WEAKLEY COUNTY, TENNESSEE

ADA EVALUATION

Architectural and Site Findings with Recommendations

TLM Associates, Inc

Finding: 38

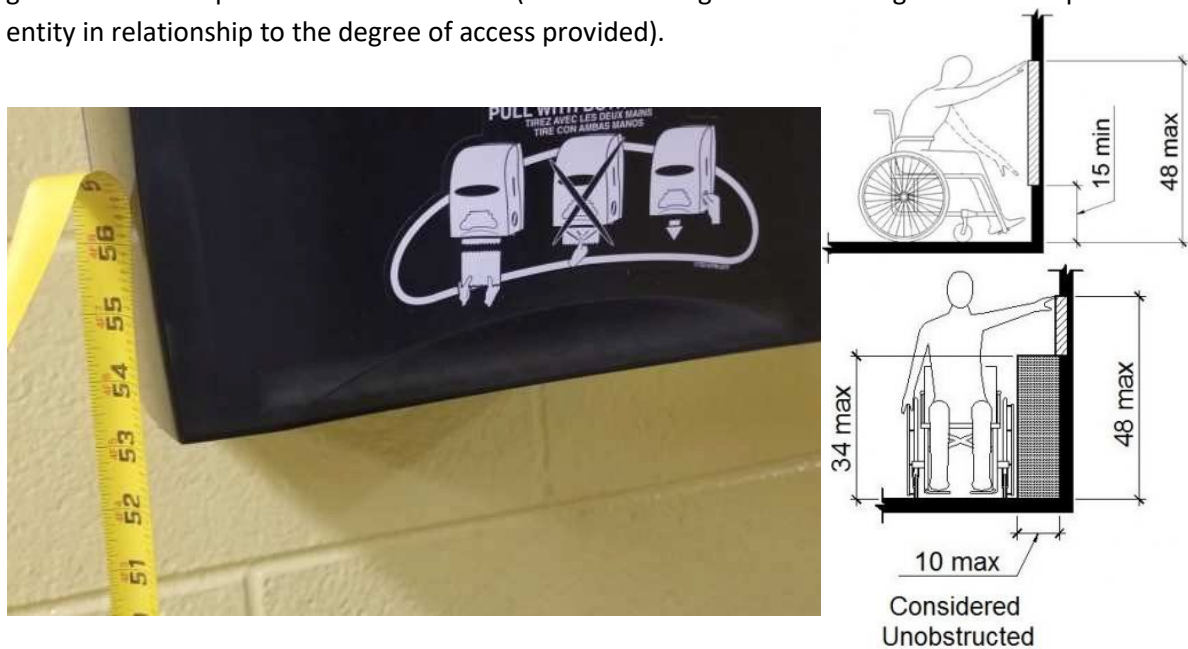
As Built: The paper towel dispenser is positioned at 53" which is not correct for either a side or front approach.
